[REDACTED]
New Communities
DTP

[REDACTED] **submission to Amendment C109moor – Merrimu
Precinct Structure Plan**

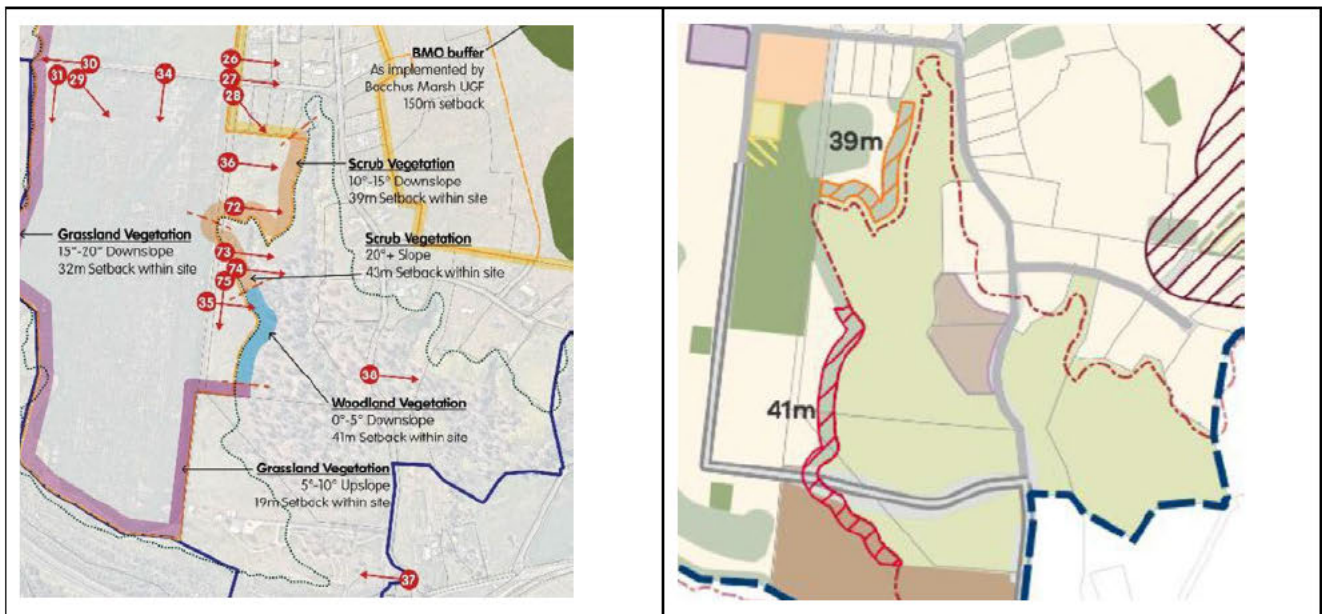
The draft PSP identifies Wetland WL-12 on Plan 10 as a major drainage asset with a significant land take within Parcel A. Among other things, this outcome unnecessarily reduces the NDA of Parcel A to 4.14ha or 12.45% of the total site area resulting in barely enough lot yield to cover the costs of delivery. We submit that the size and location of this asset is not justified. On the basis that Melbourne Water are still working to refine the drainage requirements for the precinct, every effort should be made to ensure that the size, location and number of assets are designed to avoid unnecessary impacts on the delivery of homes and community facilities. See image from Plan 10 below.

The PSP is also unclear about the catchment of WL-12. From our review we have not been able to identify, how the wetland integrates with other drainage assets within the precinct, and how stormwater is intended to be

From a land use and urban design perspective, the current location and scale of WL-12 has a material impact on development outcomes. The wetland significantly reduces net developable area of Parcel A, disrupts walkable catchments to the proposed school and local town centre, and has the potential to act as a barrier to the orderly staging and delivery of development. The asset is currently located within a parcel that is already subject to multiple constraints, resulting in limited net developable area. Due to the lower lot yield and constrained accessibility, we see this leading to poor community outcomes as a result of delays in the delivery of the planned assets.

Given the above, we request that the location and size of Wetland WL-12 be reviewed as part of the PSP process. Further detailed investigation and refinement of the drainage strategy is required to ensure that drainage infrastructure is appropriately located, reflects up-to-date technical assumptions, and supports efficient and equitable development outcomes across the precinct.

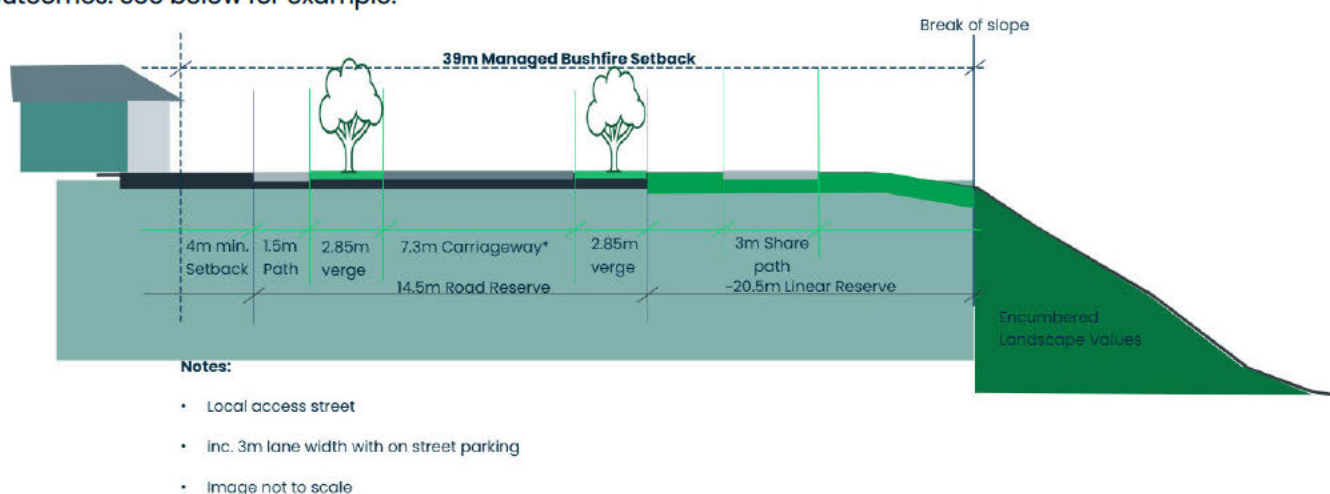
However, the PSP mapping does not clearly or consistently show how bushfire setbacks are to be applied on the ground. In particular, Plan 8 of the Draft PSP lacks clarity as to the reference point from which bushfire setbacks are measured along escarpment areas. The plan shows an apparent misalignment between the line indicating the break of slope and the commencement of the Managed Bushfire Setback (MBS).

When compared with the exhibited technical background material, the application of the bushfire setback is unclear and inconsistent. Map 5 of the *Bushfire Assessment and Development Report* prepared by Southern Cross Town Planning (April 2021) appears to show the Managed Bushfire Setback aligning with the break-of-slope line in some locations, while in other areas the setback appears to be located on different sides of the break of slope. This is further contrasted by Plan 8 of the exhibited PSP, which does not consistently show the Managed Bushfire Setback across the extent of the land. In some areas the setback is not shown at all, before re-appearing further along the escarpment edge. See image below for more detail.

For land affected by internal bushfire risk associated with areas identified as "Landscape Values" land, subdivision design responses are intended to play a key role in managing bushfire risk. In this regard, Plan 4 of the exhibited PSP identifies an escarpment interface road along this edge, with a typical cross section of approximately 14.5 metres, which is clearly intended to function as part of the bushfire risk management response. However, the PSP does not provide sufficient clarity as to how development is intended to occur in proximity to this interface, particularly whether development can proceed within bushfire setback areas provided that building envelopes are located outside the required setback distances.
